BCA & Access Assessment Report

Moree Hospital Redevelopment

Revision 4

Reference: 230307

Ground Floor

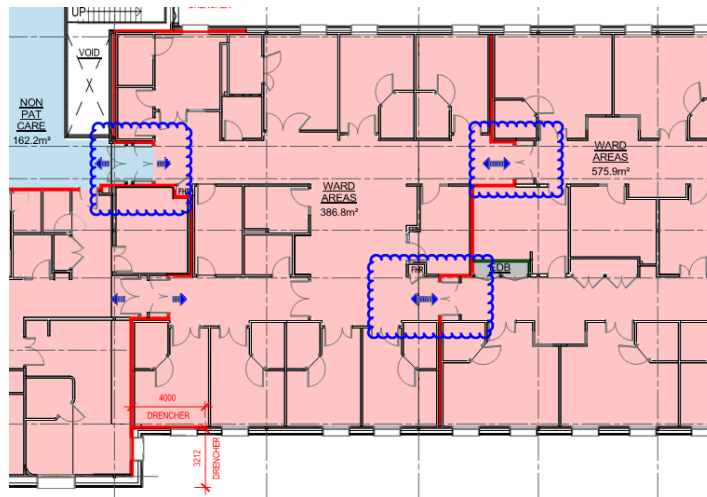
- + To justify reasonable smoke leakage through pivot smoke doors. This solution should consider the fact that pivot doors cannot stop 100% smoke leakage.
- + To permit fire and smoke doors only swing in one direction. This solution will need to rely on automatic opening doors. Alternatively, this performance solution may be justified in low population or non-patient areas such as CSSD. The nominated fire/smoke doors as indicated in blue below swing against direction of egress.

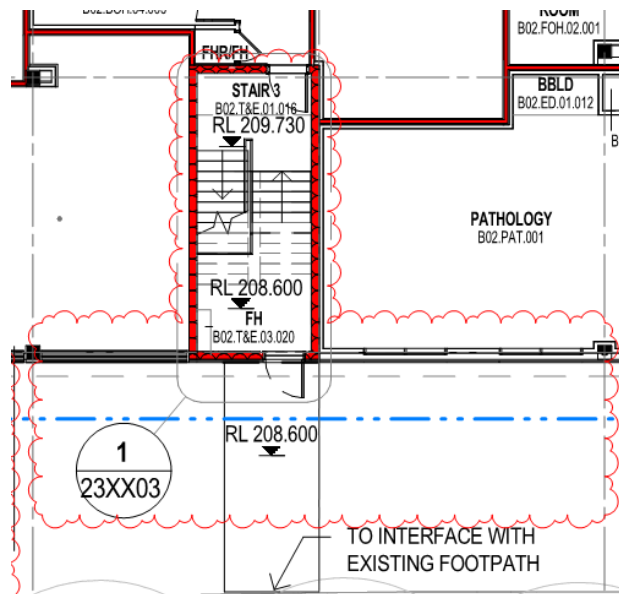
- + Stairs 2, 3 and 4 are nominated as fire isolated stairways and are required to comply with the requirements of this clause.
- + It is required to detail an unimpeded path of travel from the point of discharge on ground level stairs 2, 3 & 4 to open space.
- + The discharge from Stair 3 has now removed the external stair to Alice Street, provide confirmation of the path of travel to the street for our review.

FIGURE 34 (in part) DISTANCE BETWEEN SUCCESSIVE DOORWAYS IN VESTIBULES AND AIR LOCKS

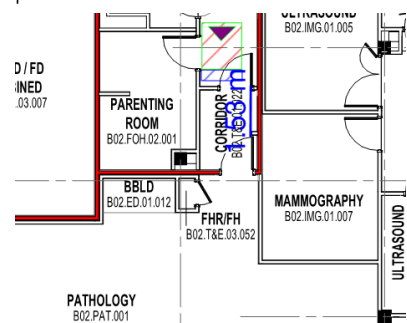
From Ground Floor the corridor that leads to Pathology, a clear distance of 1450mm has now been provided.
